## **Proposal for**

### **Submitted by the expert from the European Association of Automotive Suppliers**

## **I. Proposal for Supplement 8 to the 00 series of amendments, Supplement 5 to the 01 series of amendments, Supplement 4 to the 02 series of amendments and Supplement 1 to the 03 series of amendments to UN Regulation No. 129**

Minimum label size 40 x 40 mm

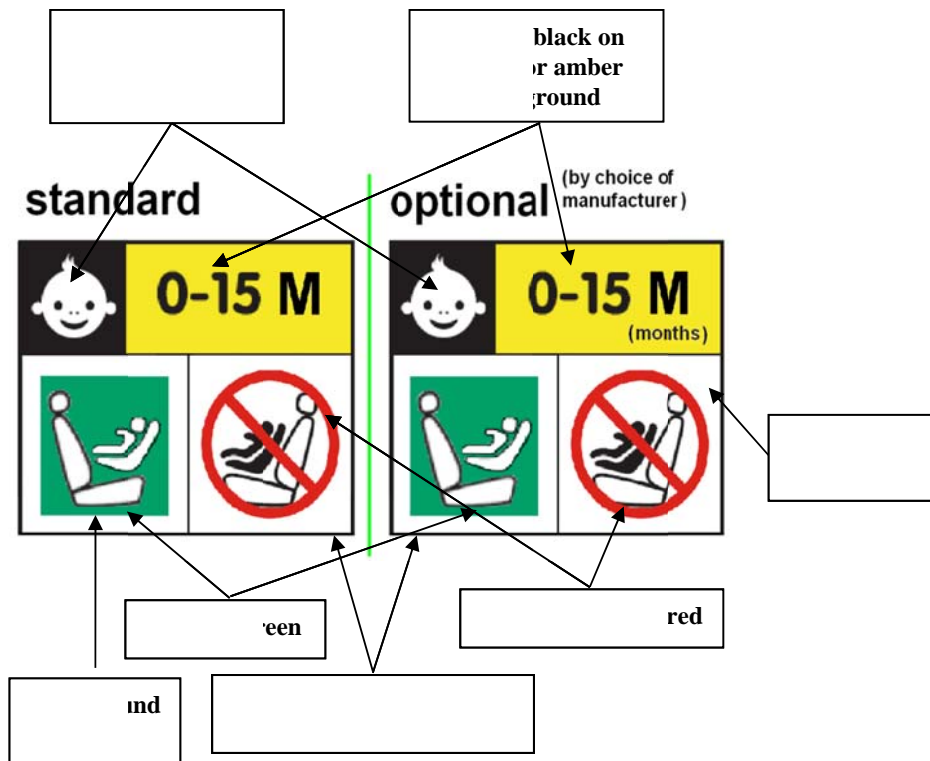
*Paragraph 4.5.* amend to read:

"4.5. In the case of Integral Enhanced Child Restraint Systems that can be used forward **and rearward** facing, it shall have the following label permanently attached on the part hosting the child and visible to the person installing an Enhanced Child Restraint System in the vehicle:

The manufacturer shall be permitted to include the word "months" to explain the symbol "M" in the label. The word "months" should be in a language commonly spoken in the country or countries where the product is sold. More than one language is allowed.

1. The label from paragraph 4.5. is intended for ECRSs which can be used forward and rearward facing which need to be clarified in the wording.
